ADDENDUM #7

Date: October 21, 2026

Project: New Locker Room Facility and Renovations to the
Existing Concession and Tennis Facilities Project at the
Merrillville High School
276 E 68th Place
Merrillville, Indiana 46410

Architect's Project #26027

SHEET
E
2.1.0-B

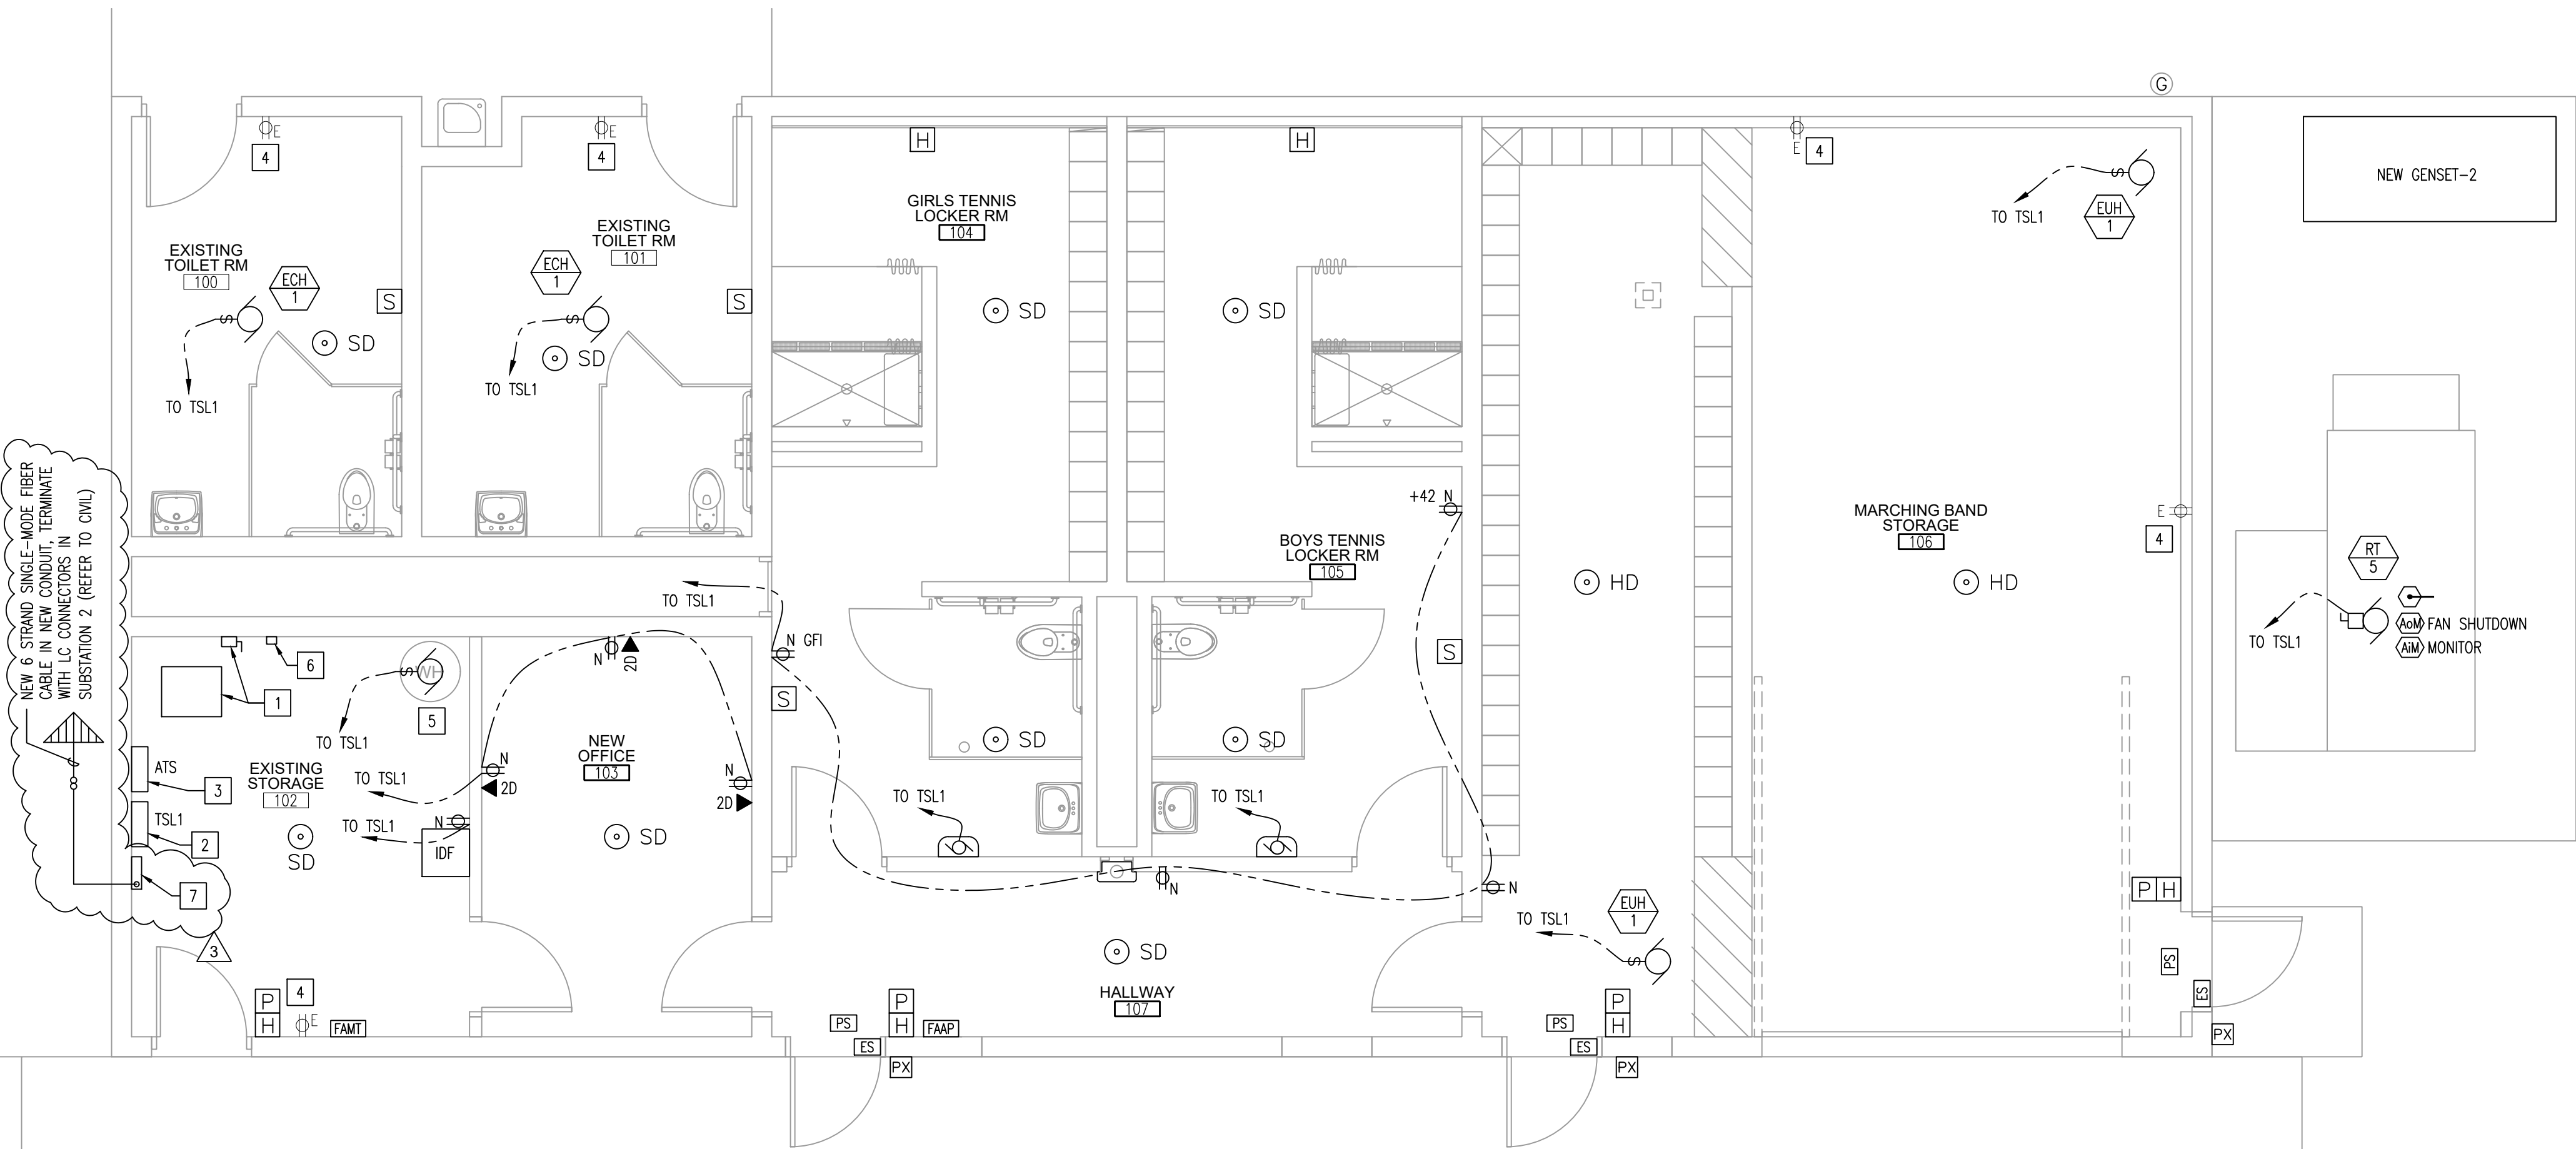
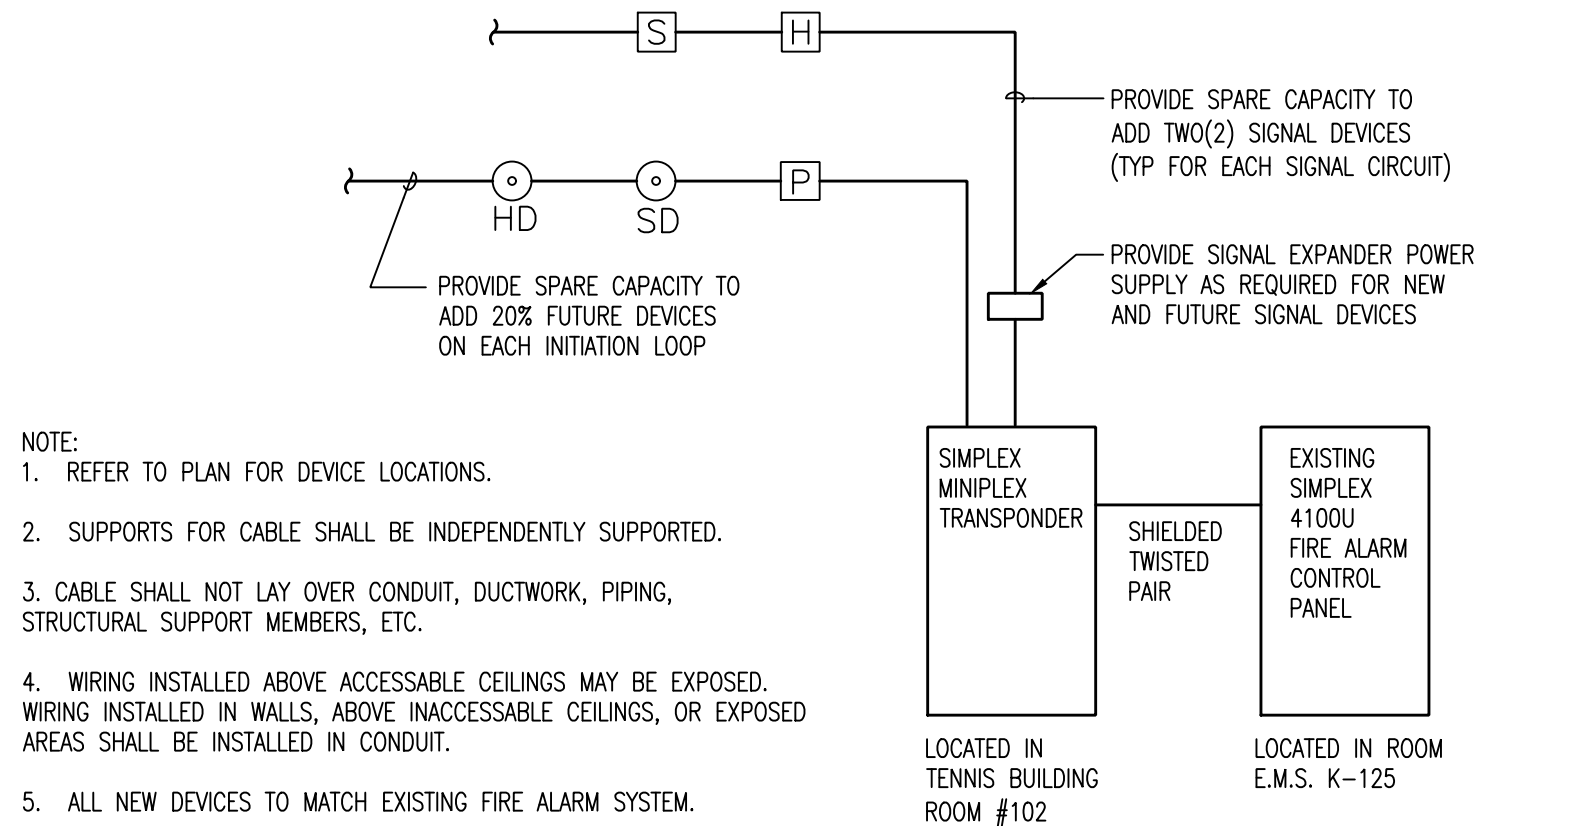
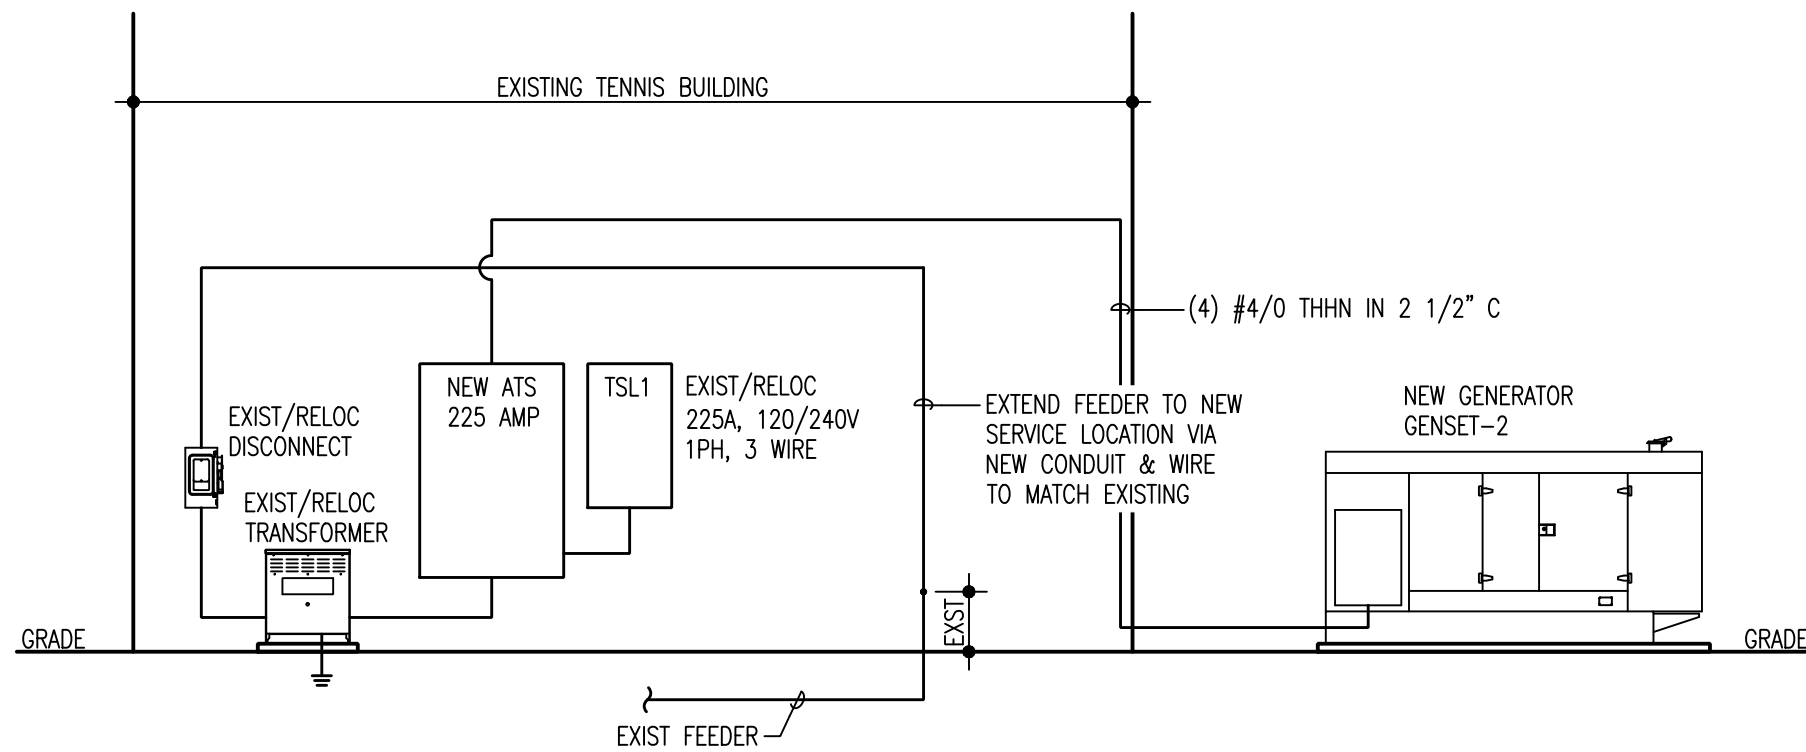
- B. Room 107 Hallway – Floor Finish VCT (Vinyl Composite Tile)
23. See attached Revised Drawing Sheet E2.1.0-B – Power Plan – Demolition & New Construction - This plan shows clouded and tagged revisions dated 10/21/2026.
